PROTECTA SHOCK ABSORBING LANYARDS

RECALL NOTICE

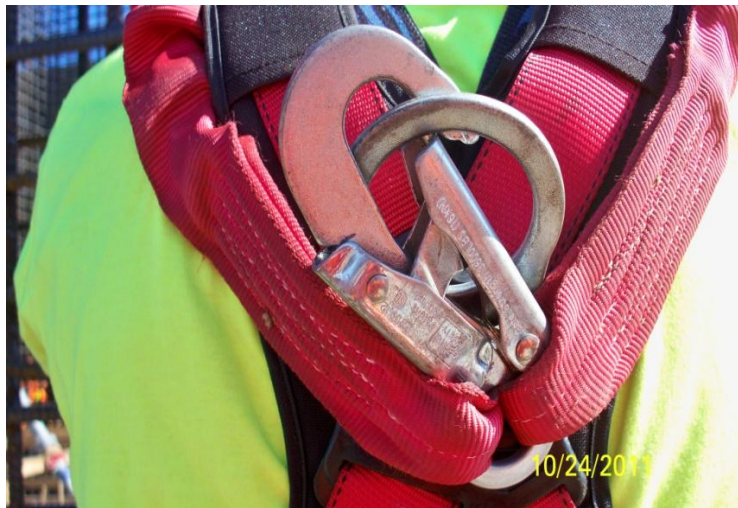
In a particular configuration when the twin lanyard legs are pulled upwards simultaneously and the snaphook gets compressed against the d-ring, the combination of forces acting on both the locking mechanism and the gate opening of the snaphook may cause the snaphook to disconnect from the d-ring. (See photo below)

The identified reason for the inadvertent disconnection is the combination of a particular style locking snaphook together with twin elastic lanyard legs attached directly to the eye of the snaphook. Although there have been no reported falls or injuries associated with the use of this configuration lanyard, CS is committed to the safety of every worker at height using our products and we are determined to resolve any potential for inadvertent disconnection to occur for the reason described above.

Capital Safety has determined that the appropriate solution to the identified issue is a combination of (a) an alternate snaphook and (b) a single lanyard connection to the eye of the snaphook. Accordingly, we have engineered a new version of the affected lanyards to take into account what we have learned about the combination of components on the Protecta shock-absorbing lanyards.
